SUBJECT: ISSUANCE OF AMENDMENT NO. 39 TO FACILITY OPERATING LICENSE
NO. NPF-29 - GRAND GULF NUCLEAR STATION, UNIT 1, REGARDING
CYCLE 3 FUEL RELOAD (TAC NO. 66376)

AMENDMENT TO FACILITY OPERATING LICENSE

Amendment No. 39
License No. NPF-29

SAFETY EVALUATION BY THE OFFICE OF NUCLEAR REACTOR REGULATION

FIGURE 3.2.1-1a MAXIMUM AVERAGE PLANAR LINEAR HEAT GENERATION RATE (MAPLHGR) VERSUS AVERAGE PLANAR EXPOSURE FOR ANF FUEL TYPE ANF299E5G3S8

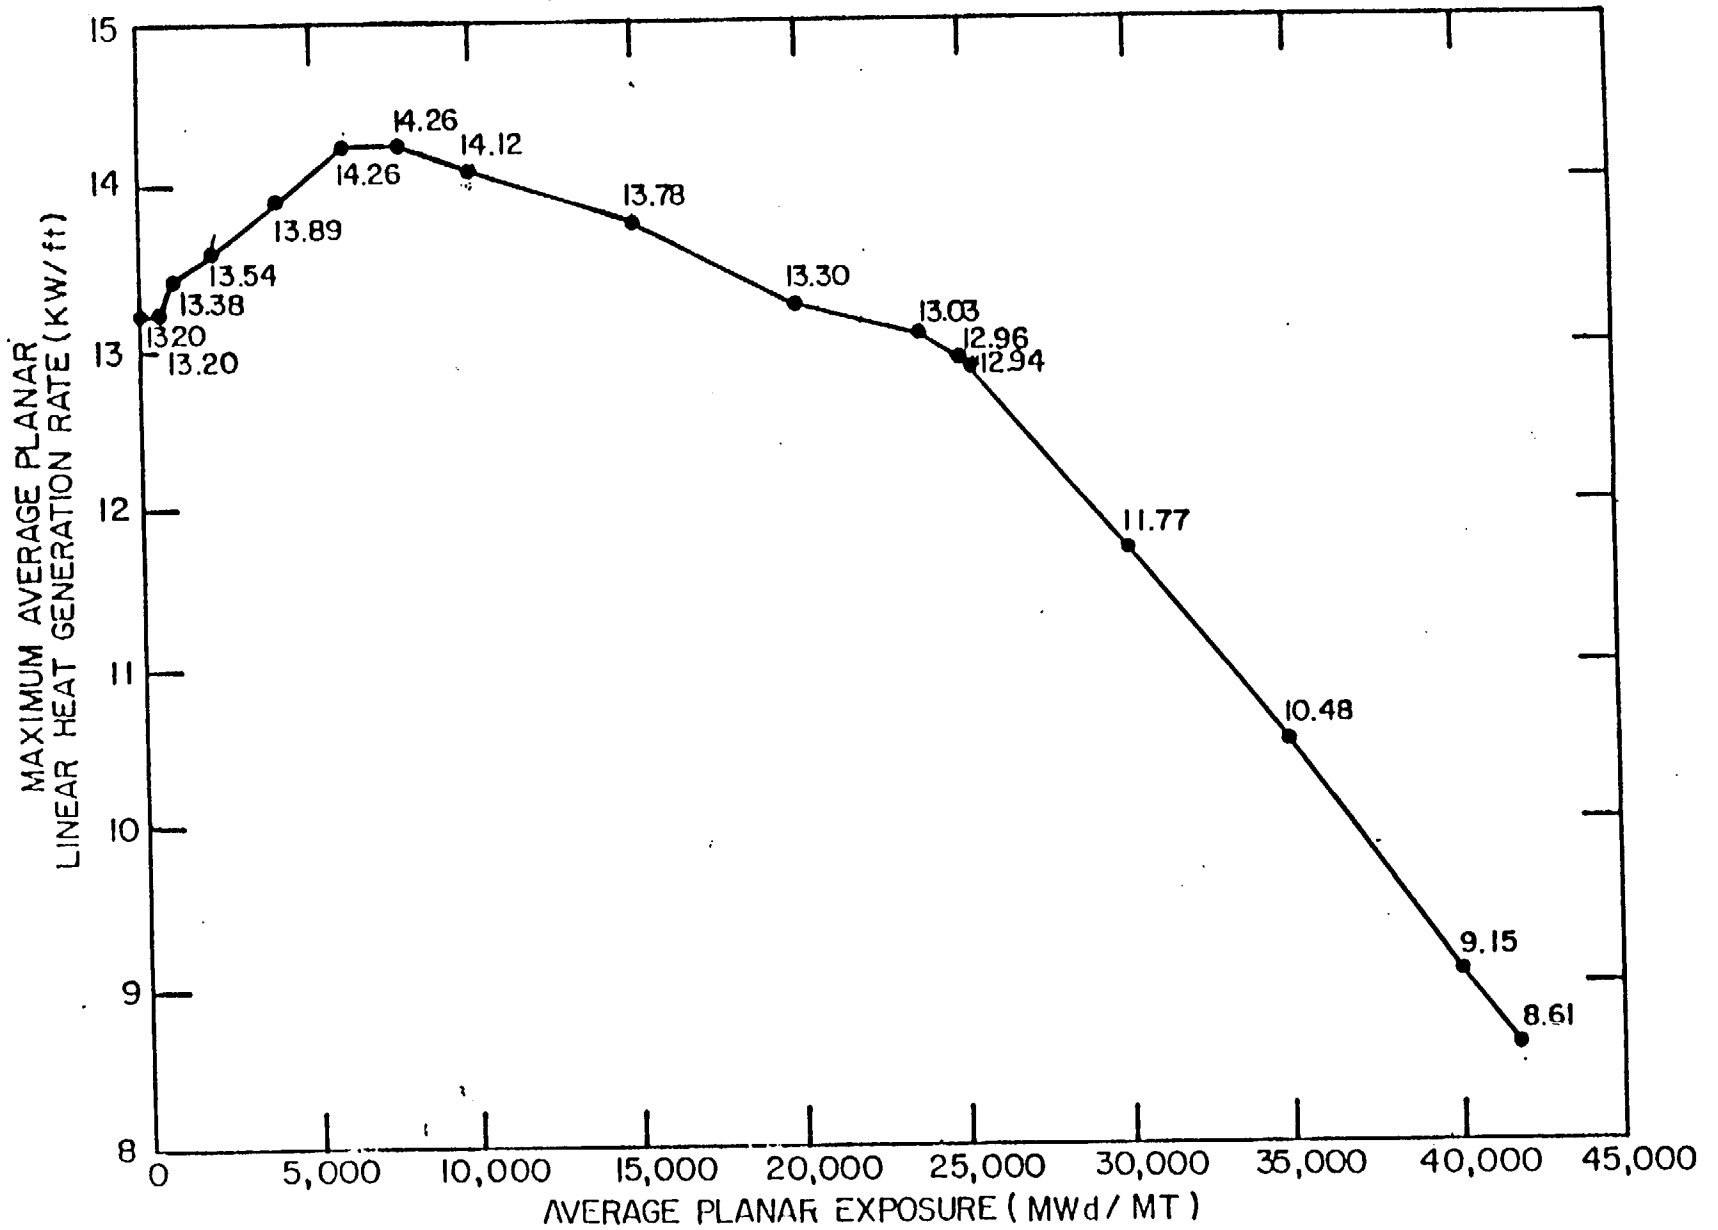
The amendment adds two maximum average planar linear heat generation rate (MAPLHGR) curves for two new types of fuel assemblies being loaded into the core for fuel cycle 3 and removes one MAPLHGR curve for a type fuel assembly being unloaded. Also, the average planar exposure limit is increased from 25,000 megawatt days per short ton (MWD/ST) to 28,500 MWD/ST. In addition, administrative changes were made to reflect the new fuel types and to correct an error in Figure 3.2.1-2.

3.2.1 During two loop operation all AVERAGE PLANAR LINEAR HEAT GENERATION RATES (APLHGRs) for each type of fuel as a function of AVERAGE PLANAR EXPOSURE shall not exceed the limits shown in Figures 3.2.1-1, 3.2.1-1a, 3.2.1-1b, or 3.2.1-1c as multiplied by the smaller of either the flow-dependent MAPLHGR factor ($MAPFAC_f$) of Figure 3.2.1-2, or the power-dependent MAPLHGR factor ($MAPFAC_p$) of Figure 3.2.1-3.

FIGURE 3.2.1-3 MAPFAC_p

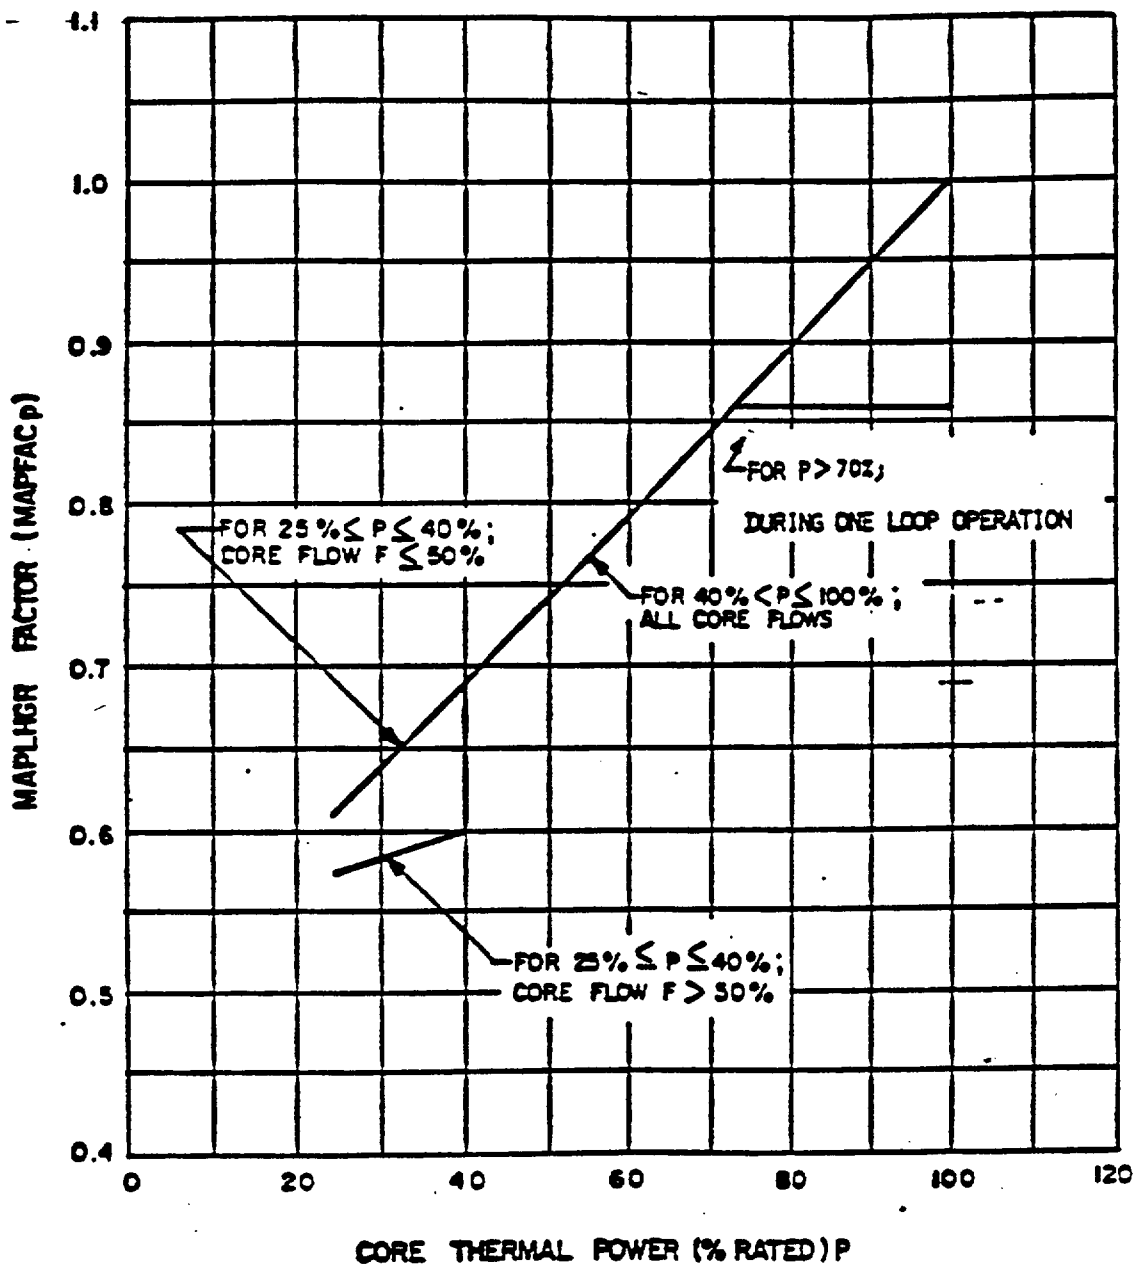
In Figure 3.6.1-3, the limiting MAPLHGR factor for power greater than 70% is incorrectly drawn at 0.84 instead of 0.86. Redrawing the limiting line at 0.86 is, therefore, acceptable.
